LOUISIANA
POWER & LIGHT

W3P88-1240
A4.05
QA

Subject: Waterford SES Unit 3
Docket No. 50-382
Detailed Control Room Design Review (DCRDR)
Supplemental Information

Saturation Margin Temperature Scale

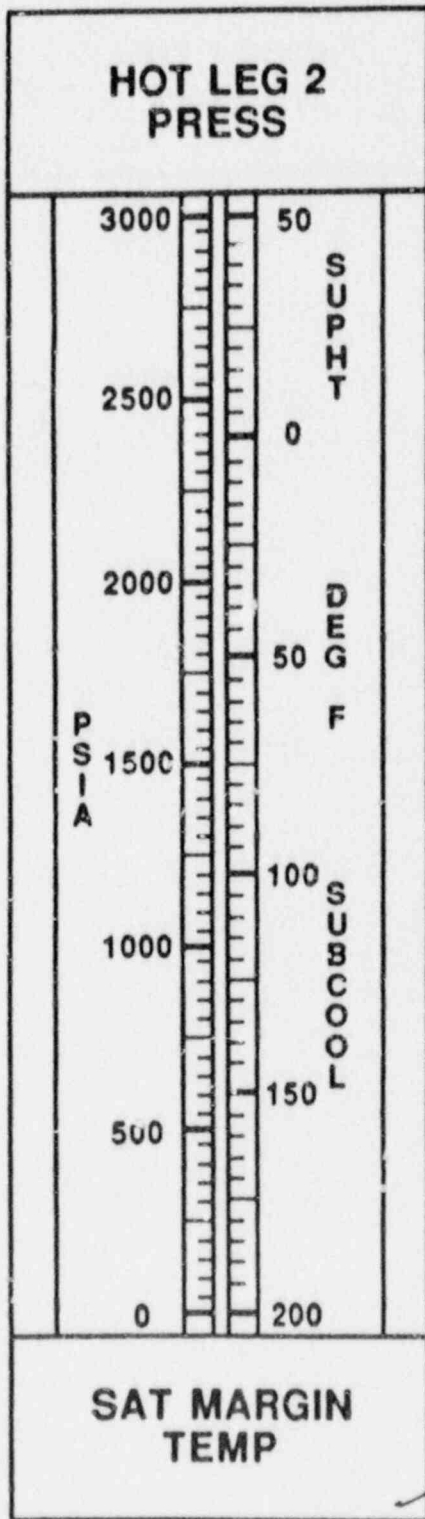
OPEN ITEM 3: CLARIFICATION OF POSITIVE AND NEGATIVE SUPERHEATED AND SUBCOOLED VALUES CONTAINED ON THE LCP43 METERS (HED 413)

Positive and negative signs will not be added to the meter faces. These are considered by the operators as being unnecessary additions to the control panels. The scales are already labeled with the abbreviations 'SUPHT' and 'SUBCOOL', which is considered sufficient indication.

LP&L is of the opinion that since Operations personnel are trained to know the difference between subcooled and superheated values (i.e., a reading in the superheat region on a saturation margin monitor would indicate superheated steam and that the core is uncovered), the current labeling convention is sufficient. Plant scales on CP-8 and LCP-43 and indicator ranges given in FSAR Table 7.4-1 (Sheets 2 & 3) provide verification that whenever a range for saturation margin temperature is given, the associated labels for subcooled/ superheat are always present. The enclosed scale provides an example of the current labeling convention used on both CP-8 and LCP-43.
